Suunnitteluvaltion lentokelpoisuusmääräys (Yhdysvallat) AD 2003-24-51**Robinson Helicopter Company. Pulttien tarkastus**

Koskee: Kaikkia Robinson R44-helikoptereita.

Liite

Suspect NAS6605-31 bolts

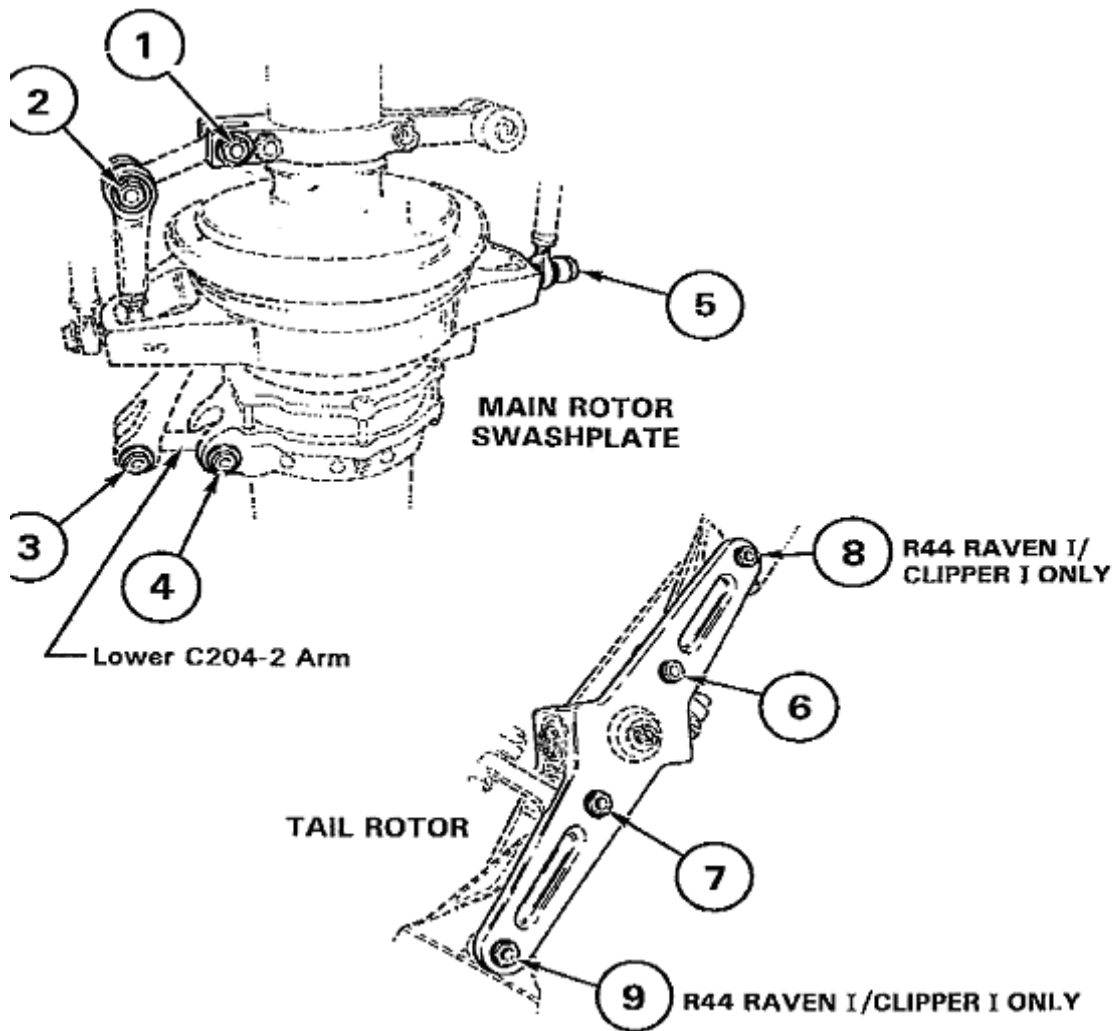
- (1) Determine if maintenance has been performed after February 7, 2003 on the areas specified in Figure 1 of this AD, and determine if any bolt, part number (P/N) NAS6605-31, shown in Figure 1 has been replaced for any reason.
- (2) If any bolt has been replaced, or if it is uncertain whether any bolt has been replaced after February 7, 2003, remove the paint from the bolt head to reveal the vendor identification marking. Determine if the bolt vendor identification is 01DO.

- (1) Visually inspect each bolt for fretting residue under the bolt head, which indicates a loose, potentially cracked bolt.
- (2) Apply 10-15 ft-lb (13-20 Nm) torque to each bolt head and verify no rotation. See Figure 1 of this AD.
- (3) If residue or rotation of the bolt is found, before further flight, replace each unairworthy bolt with an airworthy bolt that does not have a vendor identification marking of 01DO.

(e) For the helicopters specified in paragraphs (b) and (c) of this AD, within 10 hours time-in-service or by December 31, 2003, whichever occurs first, replace each bolt, P/N NAS6605-31, that has vendor identification marking 01DO on the bolt head, with an airworthy bolt, P/N NAS6605-31, that has an alternate vendor identification marking.

(f) Bolt, P/N NAS6605-31, with vendor identification marking 01DO on the bolt head, is NOT ELIGIBLE for installation on any helicopter.
